PERMIT

SEWAGE DISPOSAL SYSTEM

HOWARD COUNTY
BUREAU OF ENVIRONMENTAL HEALTH
461-9933

SUBDIVISION Middle Trail ROAD ²~~1677~~ Old Frederick Rd LOT ~~167A-D~~ #16C-D

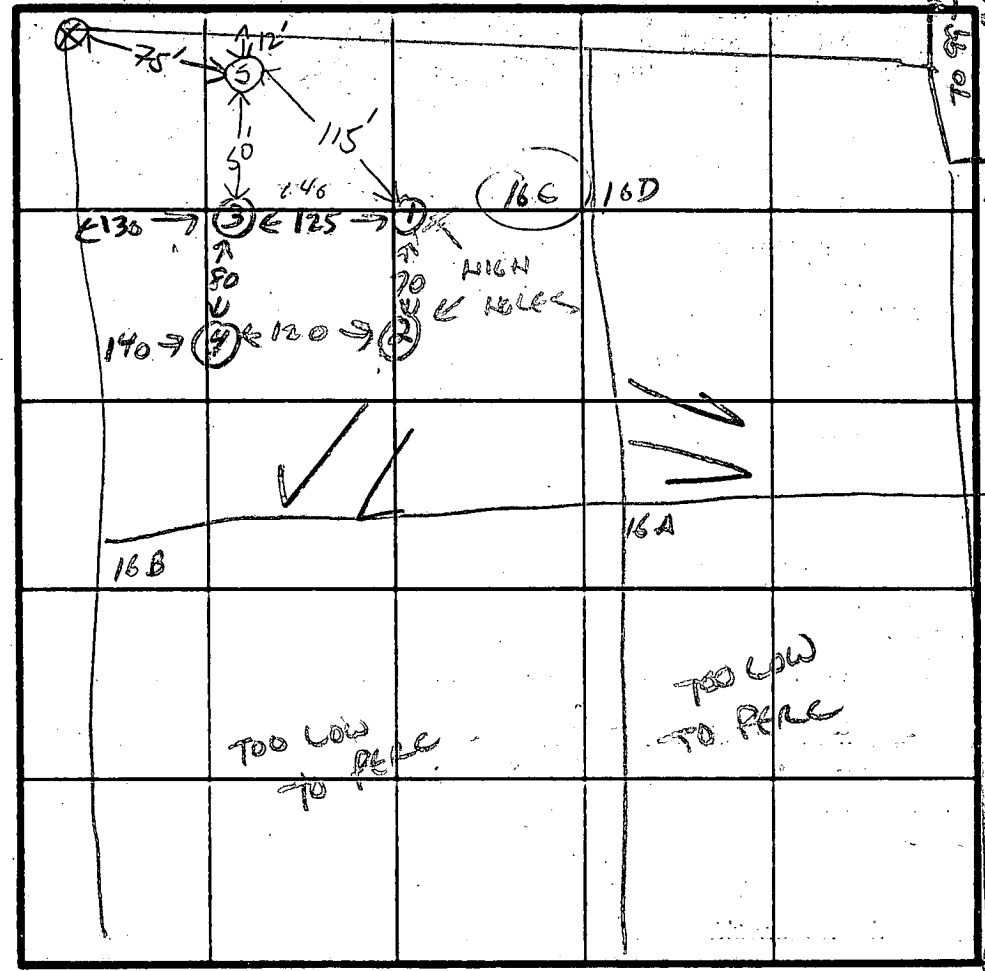
REASONS FOR REJECTION OR HOLDING NEED CERTIFIED LOCATIONS - SHALLOW SYSTEM PREFERRED.

2-28-85 - Hold for review - shallow system only. PAged

REMARKS OK FOR SHALLOW SYSTEM
SHALEY BUT TIMES 2-3 MIN

APPROVED BY C. Wilton FOR SHALLOW TRENCHES DATE 4/17/85

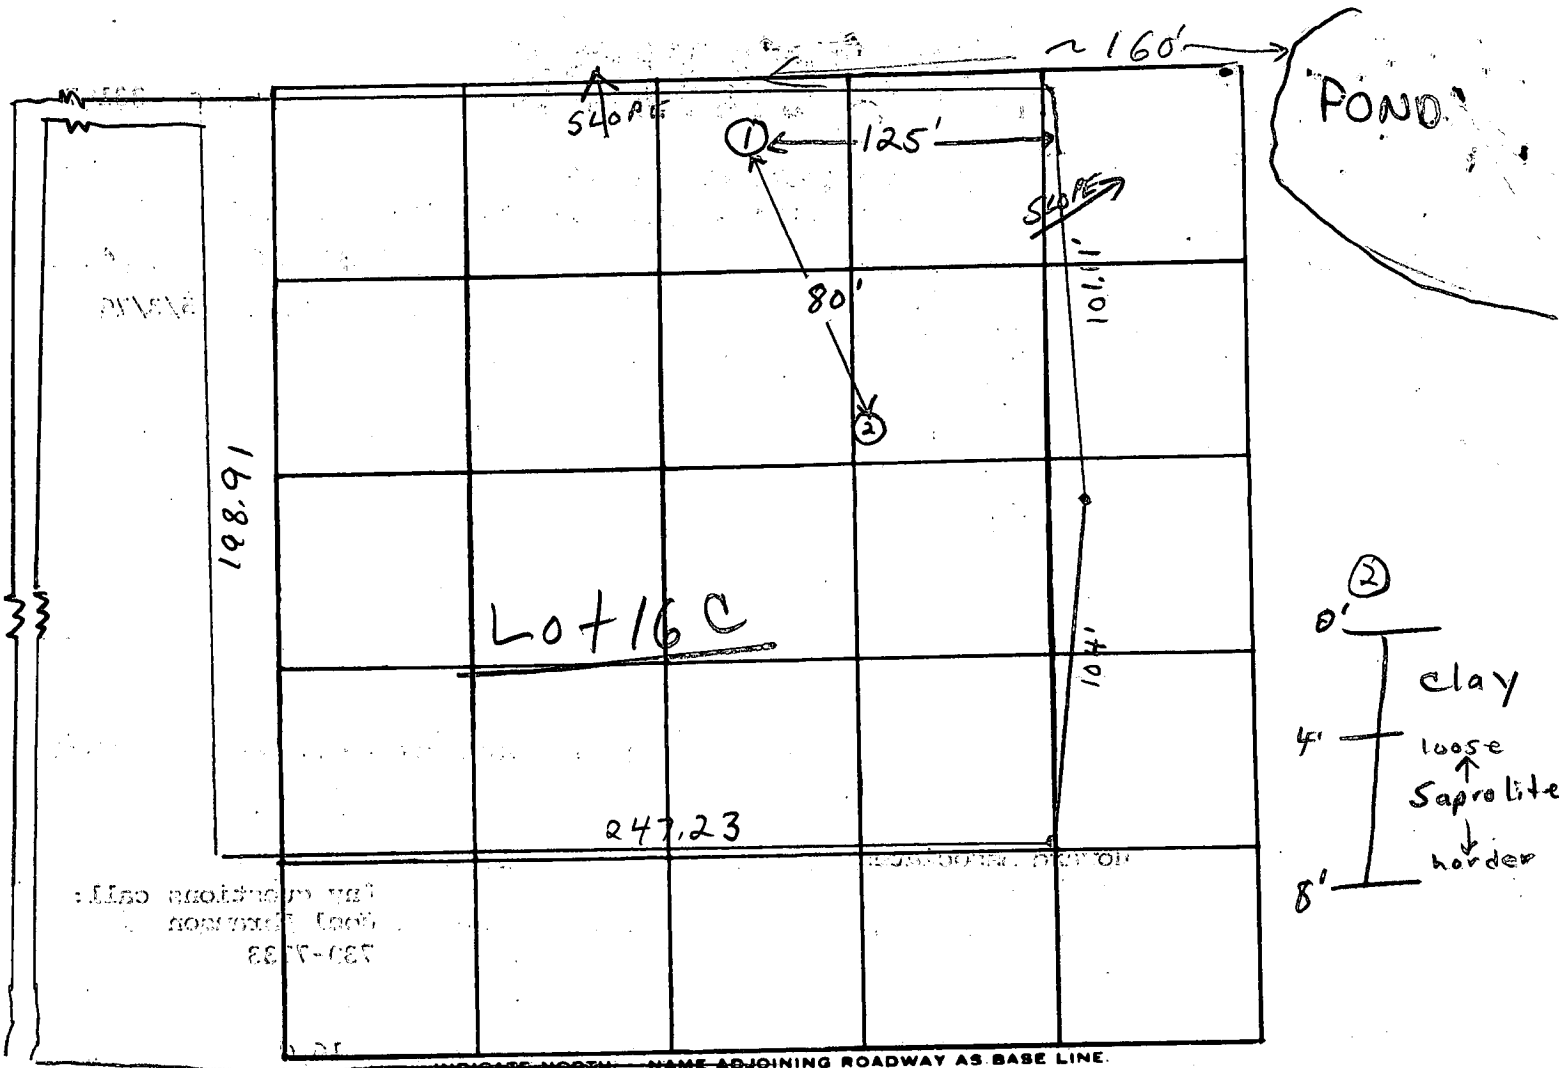
REASONS FOR REJECTION OR HOLDING unsuitable soil - rocky

REMARKS Saprolite too hard to test
 TYPE OF SOIL saprolite and clay
 TESTED BY F.S. & R. Biggs ALSO PRESENT: 5/5/70 Lendingsrew

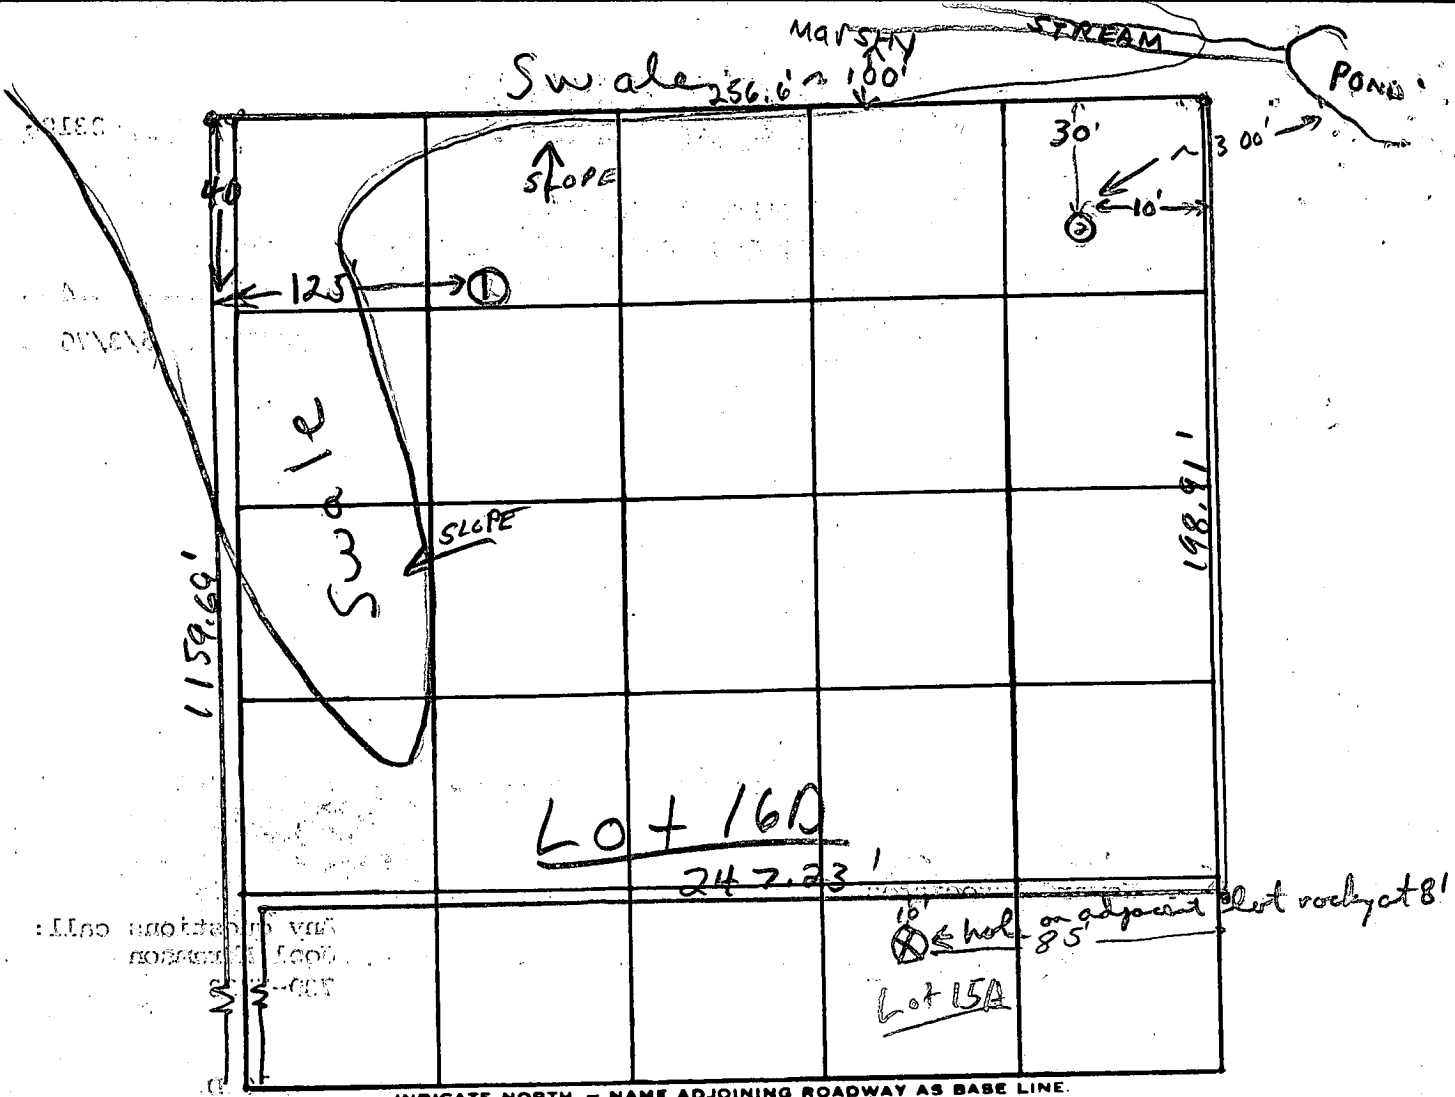
REASONS FOR REJECTION OR HOLDING unsuitable soil - Rock

REMARKS too hard to test
 TYPE OF SOIL Saprolite and clay
 TESTED BY F.S. ALSO PRESENT: Leadbins crew

LOCATION SURVEY
16277 OLD FREDERICK ROAD
4TH ELECTION DISTRICT
HOWARD COUNTY M.D.

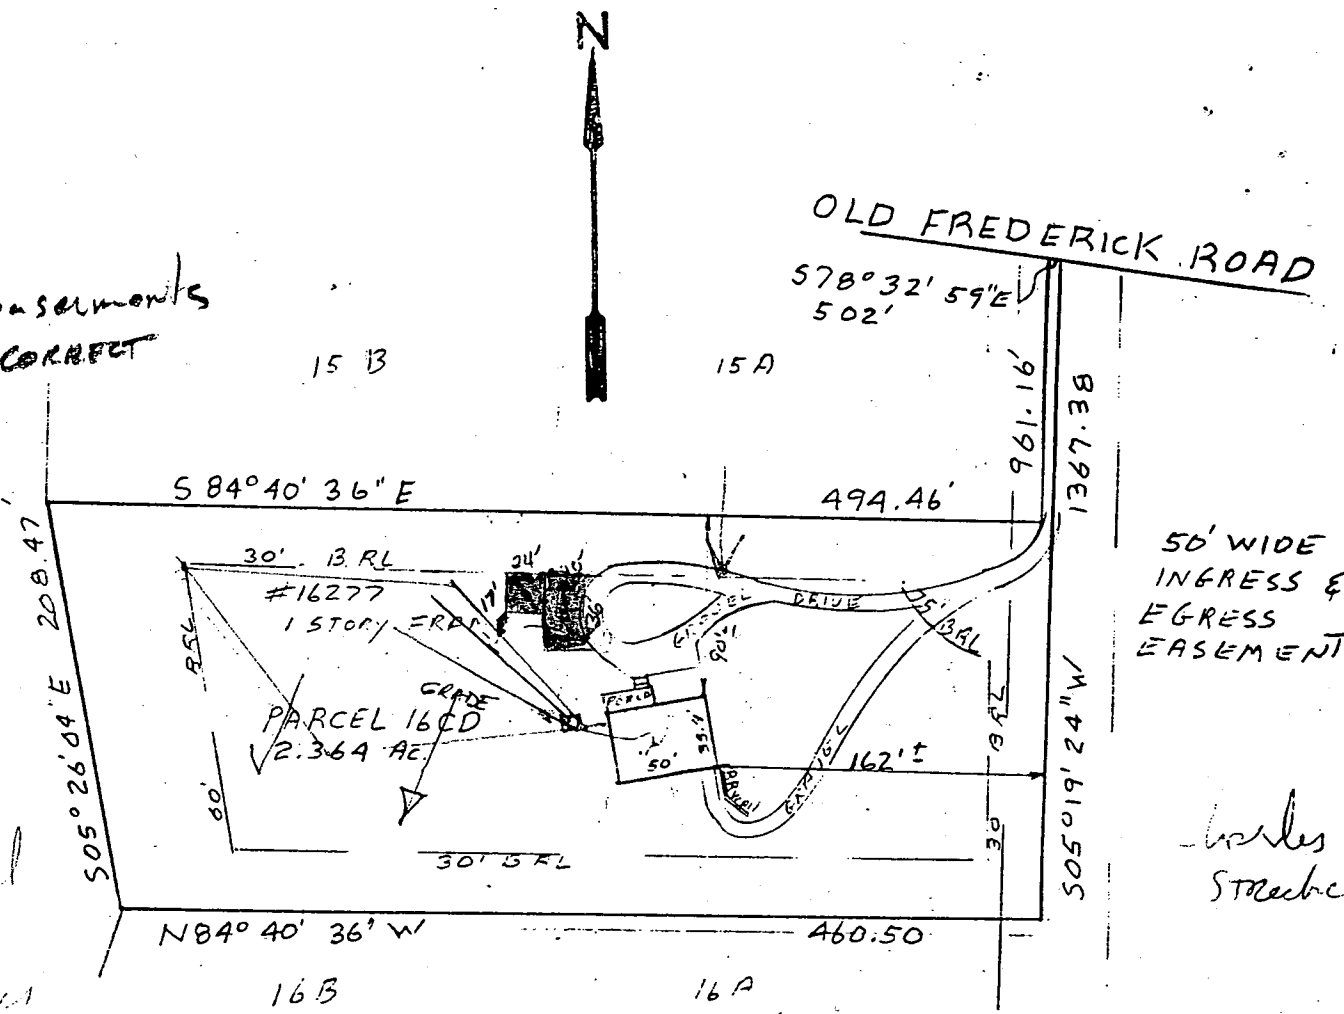
I certify the proposed
Garage location and measurements
as shown are actual & correct
to the best of knowledge
NOTE: TRENCHES ARE 17'-0"
FROM CLOSEST CORNER
OF GARAGE.

3/29/95 Tentative approval
as shown
Chiltheater
R.S.

LOCATION SURVEY

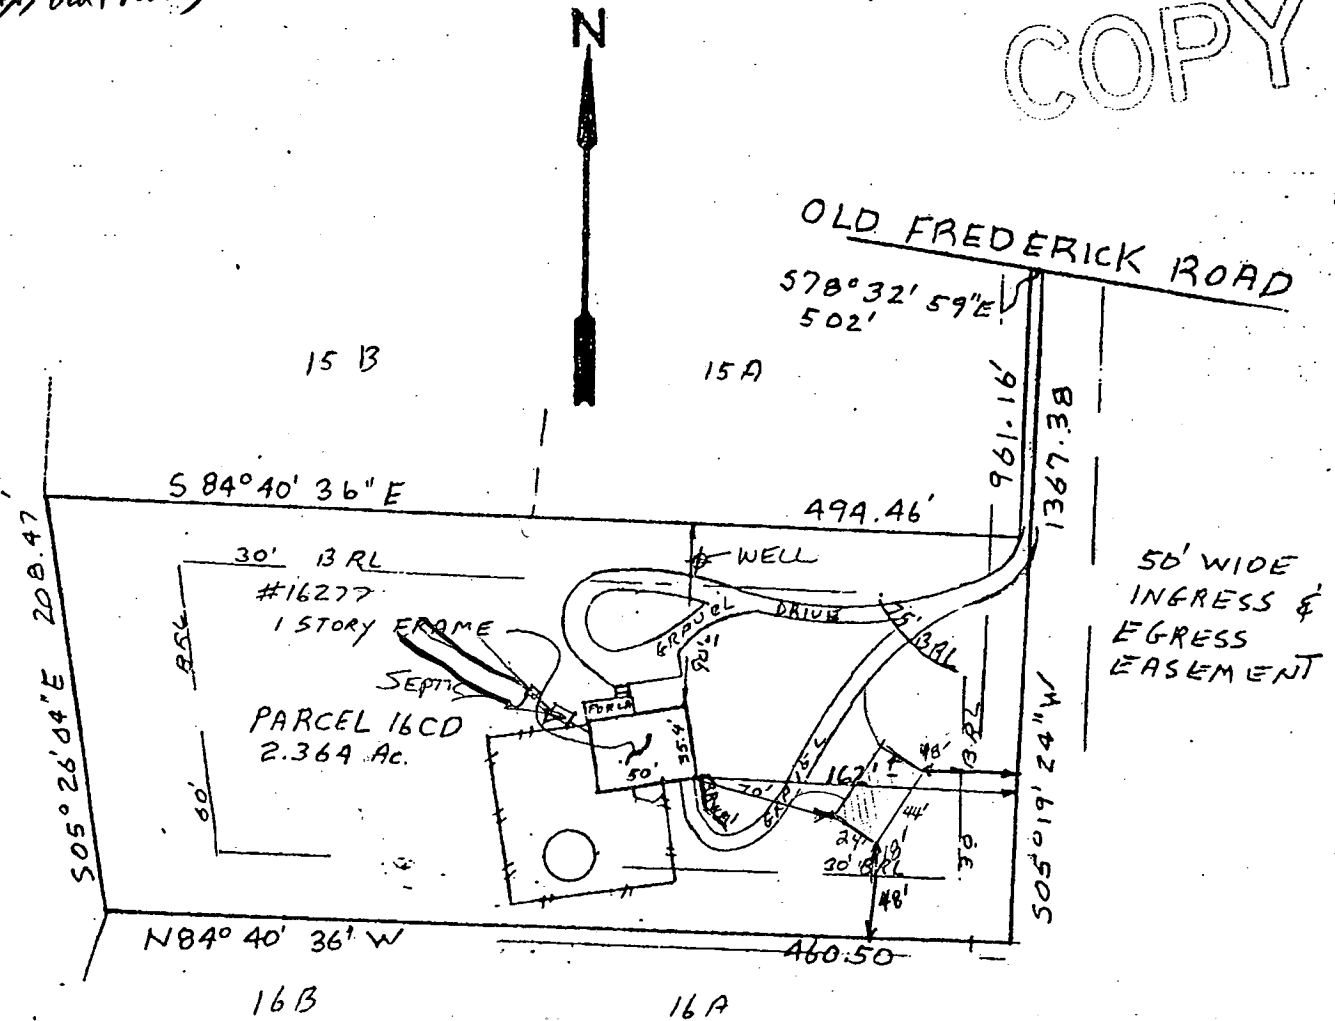
No Conflict with
well or Septic. Recommend
approval. RPP 11/9/00
